SAD 228 DRAINAGE REPORT

SPECIAL ASSESSMENT DISTRICT 228–VOL. 1
PAVING PLAN & PROFILE
PAPAGAYO ROAD

SPECIAL ASSESSMENT DISTRICT 228-VOL. 1
POND 4 GRADING PLAN

SPECIAL ASSESSMENT DISTRICT 228–VOL. 1
POND 5 GRADING & DRAINAGE PLAN

SPECIAL ASSESSMENT DISTRICT 228–VOL. 1
POND 5 GRADING & DRAINAGE PLAN

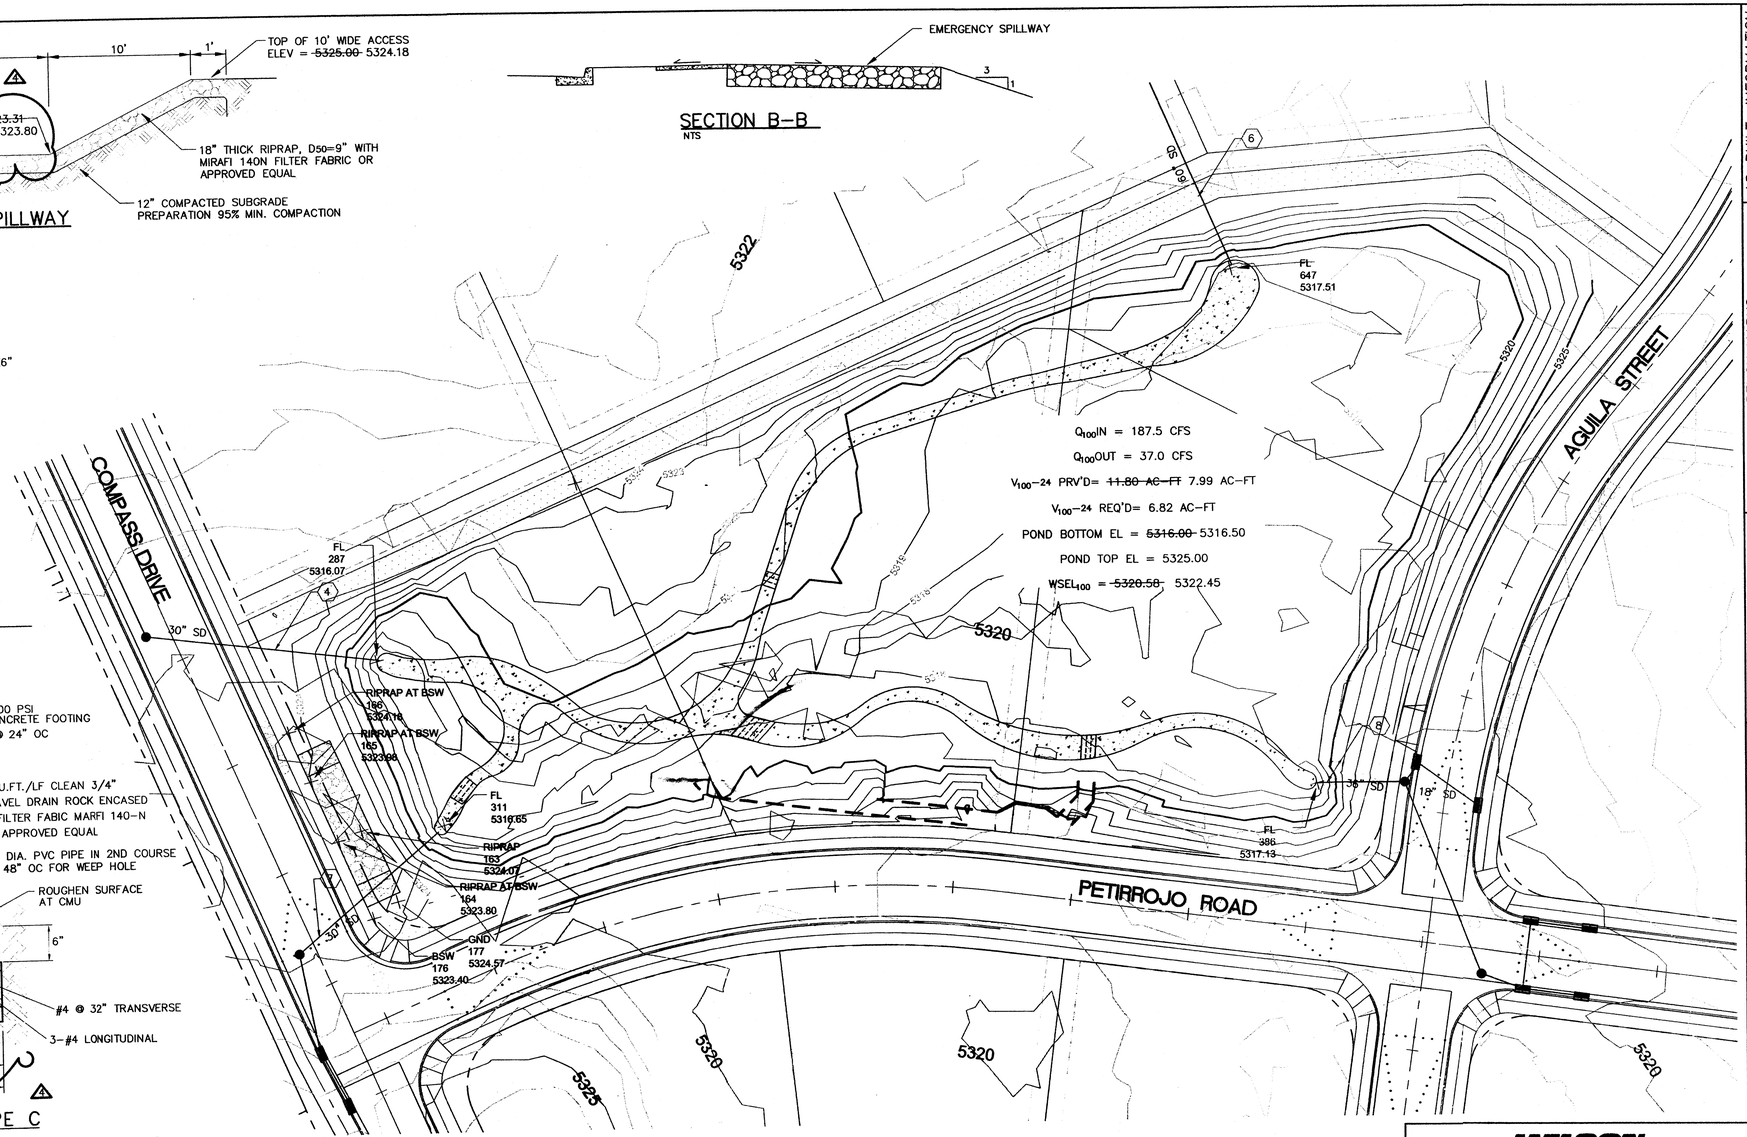
4. INSTALL 30" POND OUTLET STRUCTURE, ~~INV =5315.75.~~ INV=5316.07 SEE SHEET 124 FOR DETAIL.
5. STA 19+17, 15' RT, INSTALL 15' WIDE DRIVEPAD PER COA STD DWG 2425.

6. INSTALL 48 LF 60" SD PIPE @ 0.35%, ~~INV = 5317.24,~~ INV=5317.51 1– 60" POND INLET STRUCTURE. SEE SHEET 124 FOR DETAIL.
7. INSTALL 81.5 LF 24" PIPE @ 0.12%, ~~INV = 5316.20,~~ INV=5316.65 1–24" POND INLET STRUCTURE.

8. INSTALL 34 LF 36" PIPE @ 0.50%, INV=5317.13 ~~INV = 5317.00,~~ 1–36" INLET STRUCTURE. SEE SHEET 124 FOR DETAIL.
9. INSTALL LOW FLOW CHANNEL. SEE DETAIL THIS SHEET.

14. INSTALL RETAINING WALL PER DETAIL THIS SHEET. COST WILL BE INCIDENTAL PER LANDSCAPE LUMP SUM BID ITEM.
15. INSTALL 5–24" SIDEWALK CULVERT PER COA STD DWG 2236. SKEW ANGLE = 26°

SPECIAL ASSESSMENT DISTRICT 228-VOL. 1
POND 8 GRADING PLAN

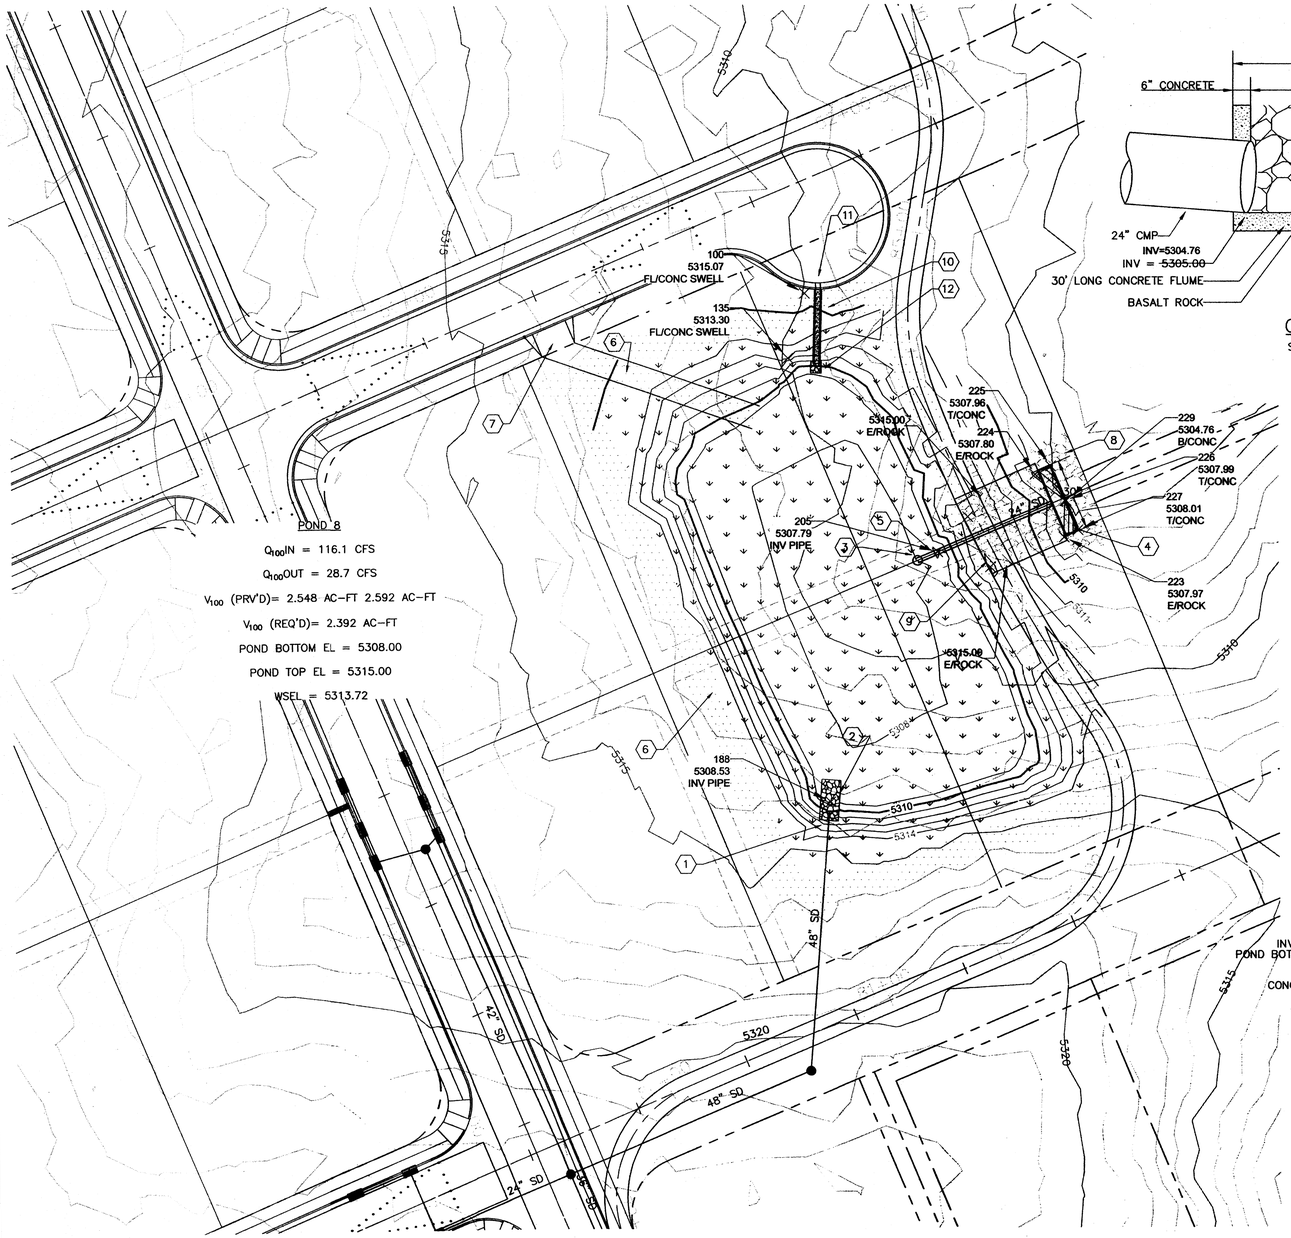
1. INSTALL 108 LF 48" PIPE @ 0.46%, INV = ~~5308.50~~; INV=5308.53
   1-48" SD POND INLET STRUCTURE, SEE SHEET 124.
2. INSTALL 8'W X 17'L X 18"D, D50=9" RIPRAP BLANKET WITH MIRAFI 140N FILTER FABRIC OR APPROVED EQUAL.

3. INSTALL 42" RISER, 3 ROW OF 11-4" DIA STAGGERED HOLES. SEE DETAIL THIS SHEET.
4. INSTALL 30' LONG, 5' WIDE CONCRETE FLUME. SEE DETAIL THIS SHEET.
5. INSTALL 62 LF 24" CMP, S = 3.23%.
   INV DOWN = ~~5305.00~~
   INV=5304.76

SPECIAL ASSESSMENT DISTRICT 228-VOL. 1
POND 9 GRADING PLAN

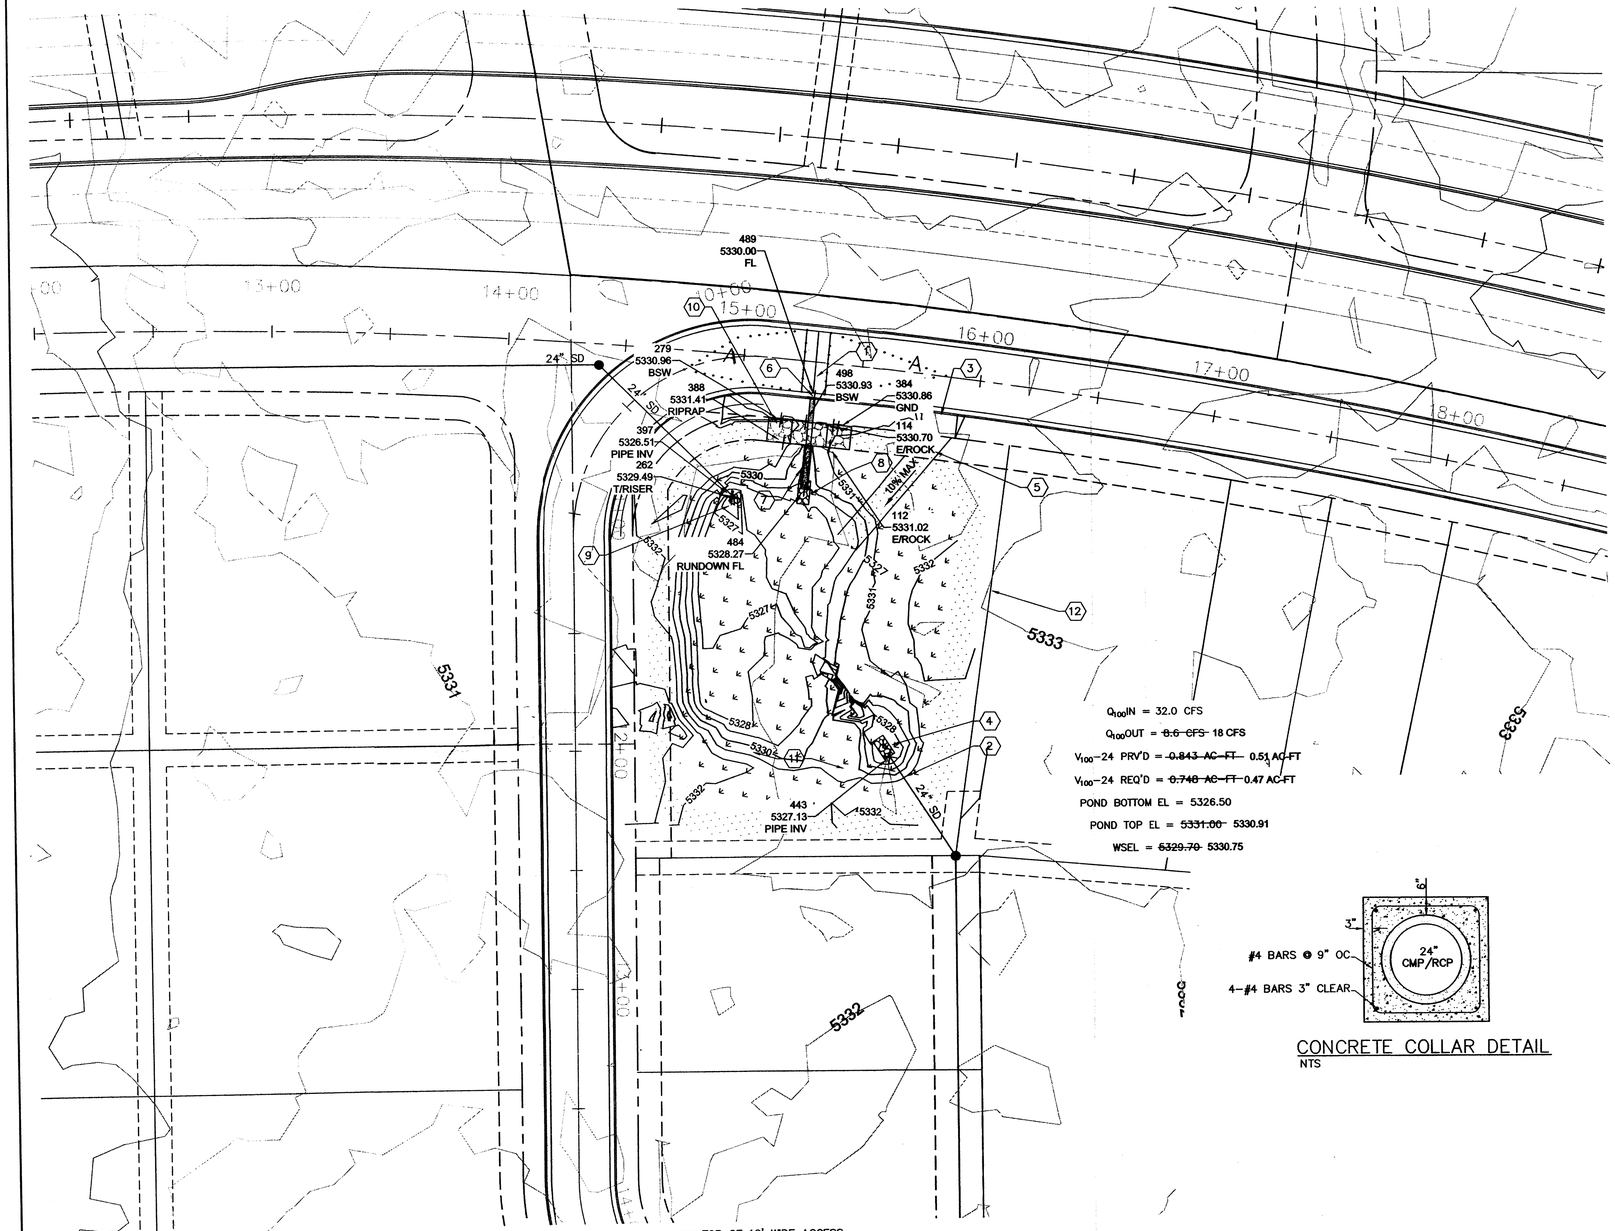
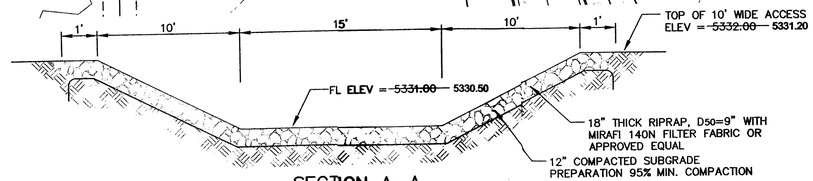
Q_{100}OUT = ~~8.6 CFS~~ 18 CFS

V_{100}–24 PRV'D = ~~0.843 AC-FT~~ 0.51 AC-FT

V_{100}–24 REQ'D = ~~0.748 AC-FT~~ 0.47 AC-FT

SPECIAL ASSESSMENT DISTRICT 228–VOL. 1
POND 5 GRADING & DRAINAGE PLAN

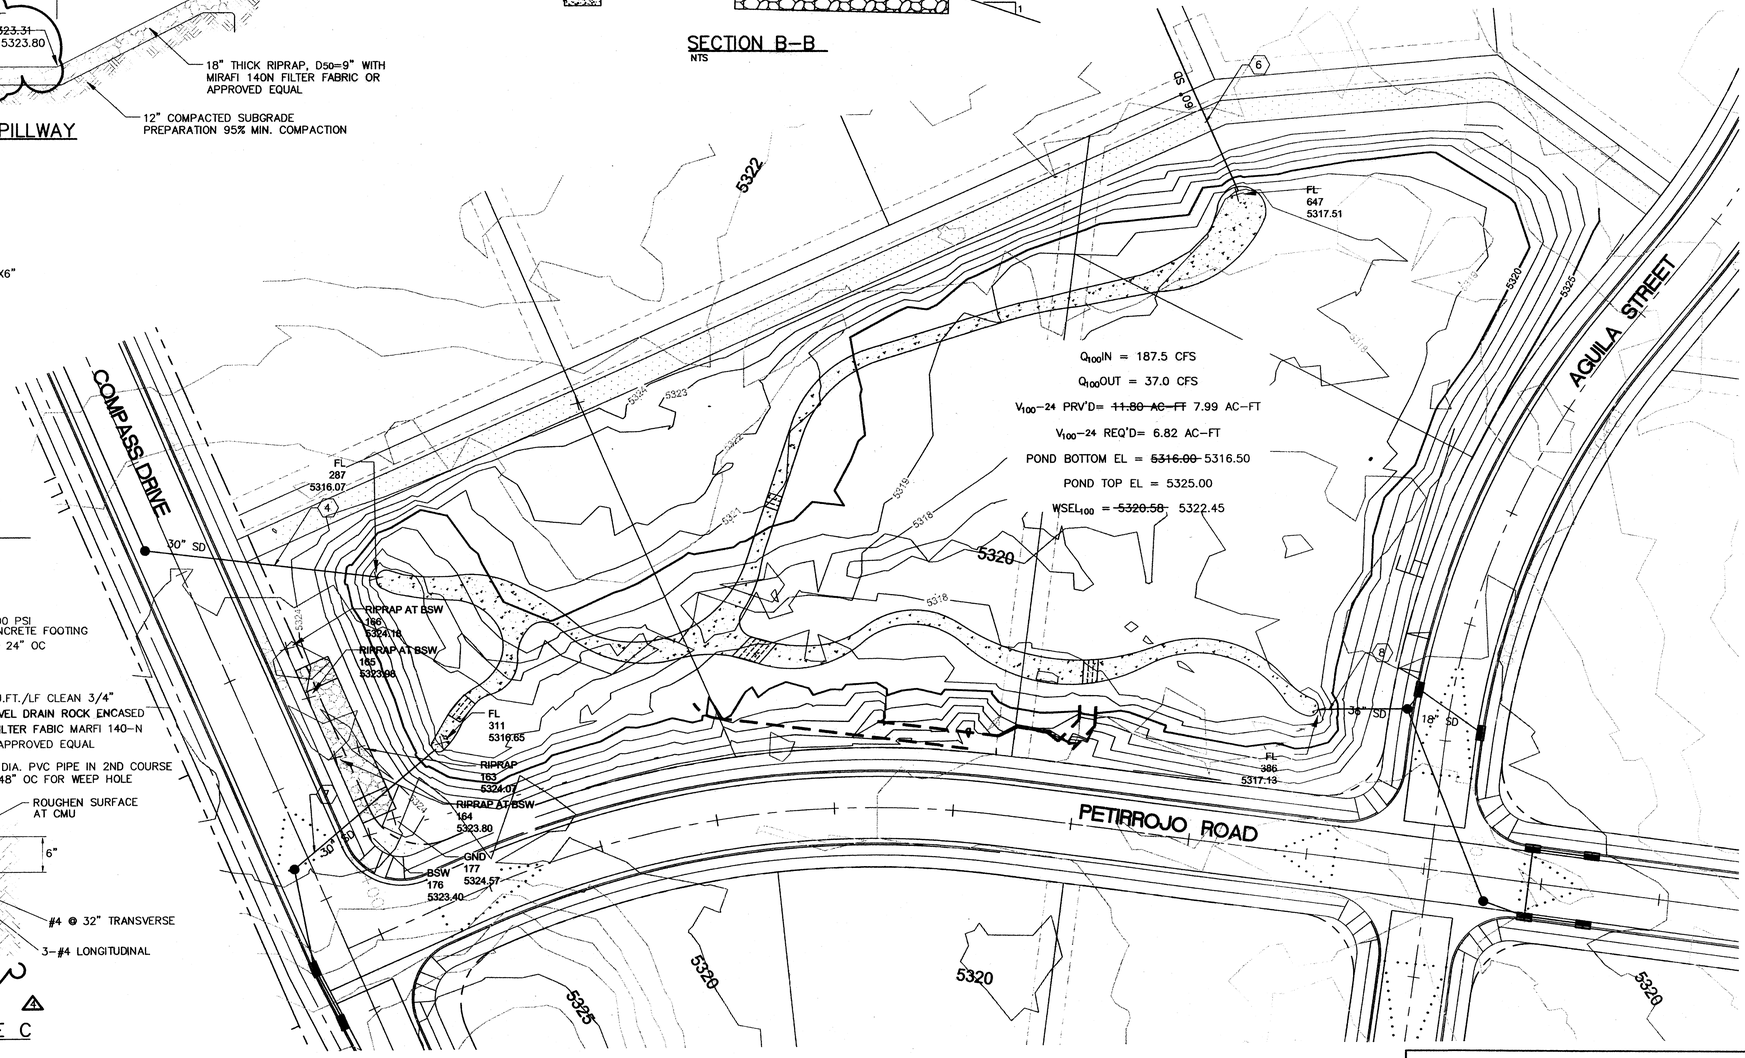
4. INSTALL 30" POND OUTLET STRUCTURE, ~~INV =5315.75.~~ INV=5316.07 SEE SHEET 124 FOR DETAIL.
5. STA 19+17, 15' RT, INSTALL 15' WIDE DRIVEPAD PER COA STD DWG 2425.

6. INSTALL 48 LF 60" SD PIPE @ 0.35%, ~~INV = 5317.24,~~ INV=5317.51 1– 60" POND INLET STRUCTURE. SEE SHEET 124 FOR DETAIL.
7. INSTALL 81.5 LF 24" PIPE @ 0.12%, ~~INV = 5316.20,~~ INV=5316.65 1–24" POND INLET STRUCTURE.

8. INSTALL 34 LF 36" PIPE @ 0.50%, ~~INV = 5317.00,~~ INV=5317.13 1–36" INLET STRUCTURE. SEE SHEET 124 FOR DETAIL.
9. INSTALL LOW FLOW CHANNEL. SEE DETAIL THIS SHEET.

14. INSTALL RETAINING WALL PER DETAIL THIS SHEET. COST WILL BE INCIDENTAL PER LANDSCAPE LUMP SUM BID ITEM.
15. INSTALL 5–24" SIDEWALK CULVERT PER COA STD DWG 2236. SKEW ANGLE = 26°

SPECIAL ASSESSMENT DISTRICT 228-VOL. 1
POND 8 GRADING PLAN

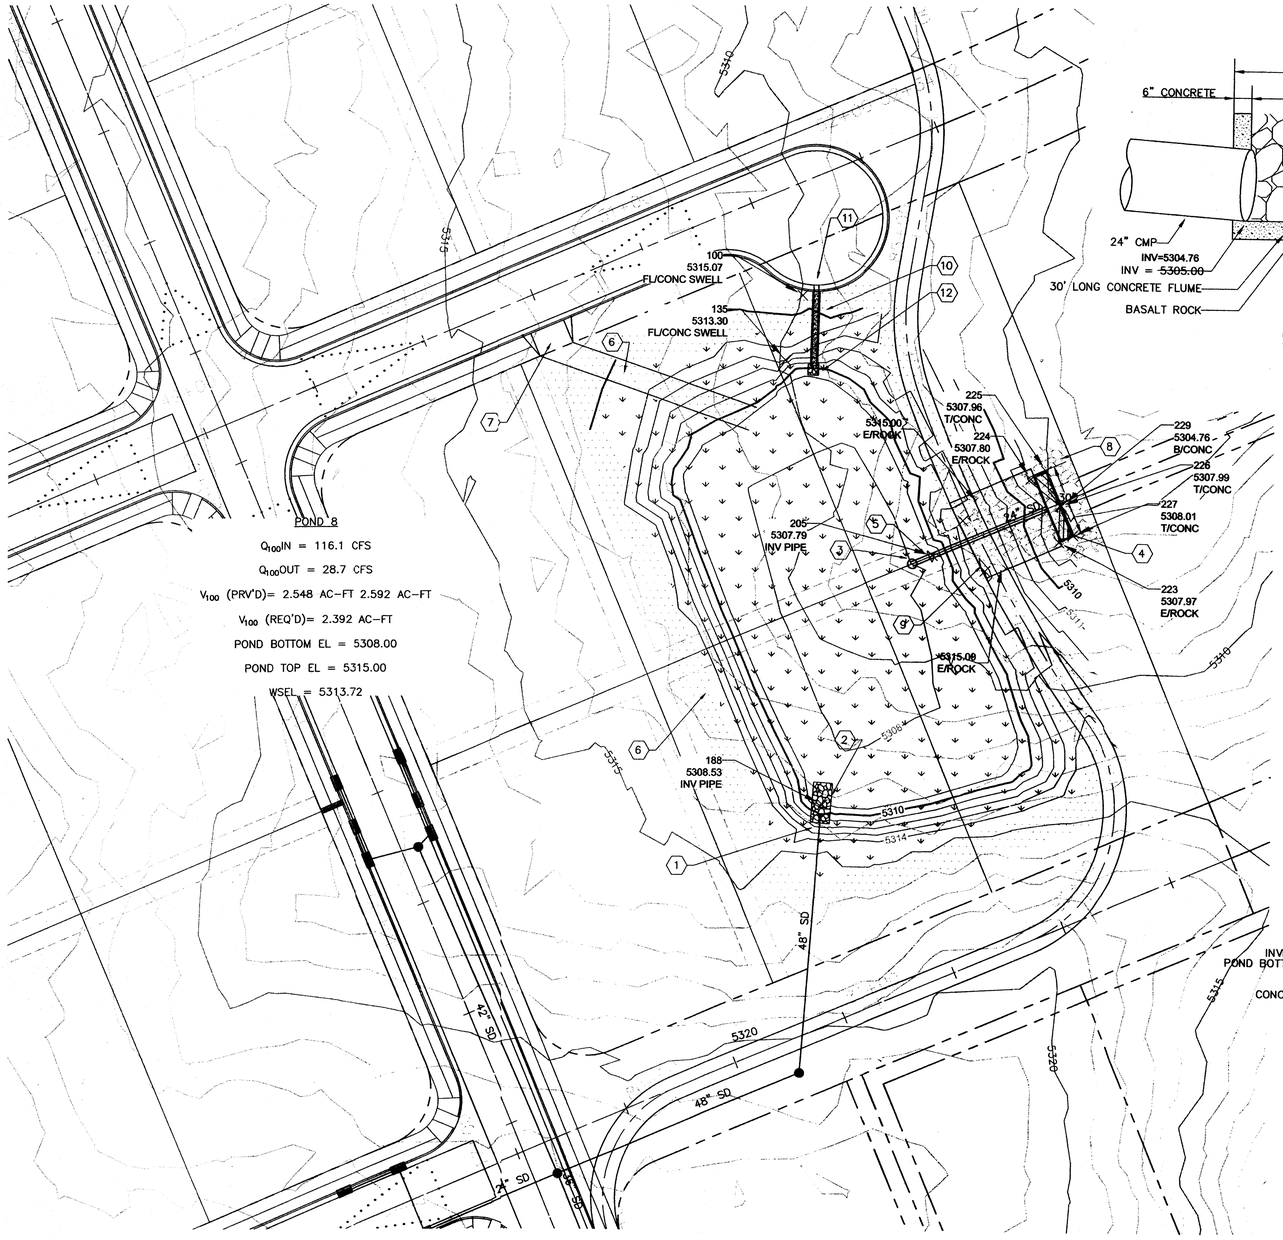
1. INSTALL 108 LF 48" PIPE @ 0.46%, INV = ~~5308.50~~; INV=5308.53 1-48" SD POND INLET STRUCTURE, SEE SHEET 124.
2. INSTALL 8'W X 17'L X 18"D, D_{50}=9" RIPRAP BLANKET WITH MIRAFI 140N FILTER FABRIC OR APPROVED EQUAL.

3. INSTALL 42" RISER, 3 ROW OF 11-4" DIA STAGGERED HOLES. SEE DETAIL THIS SHEET.
4. INSTALL 30' LONG, 5' WIDE CONCRETE FLUME. SEE DETAIL THIS SHEET.
5. INSTALL 62 LF 24" CMP, S = 3.23%. INV DOWN = ~~5305.00~~ INV=5304.76
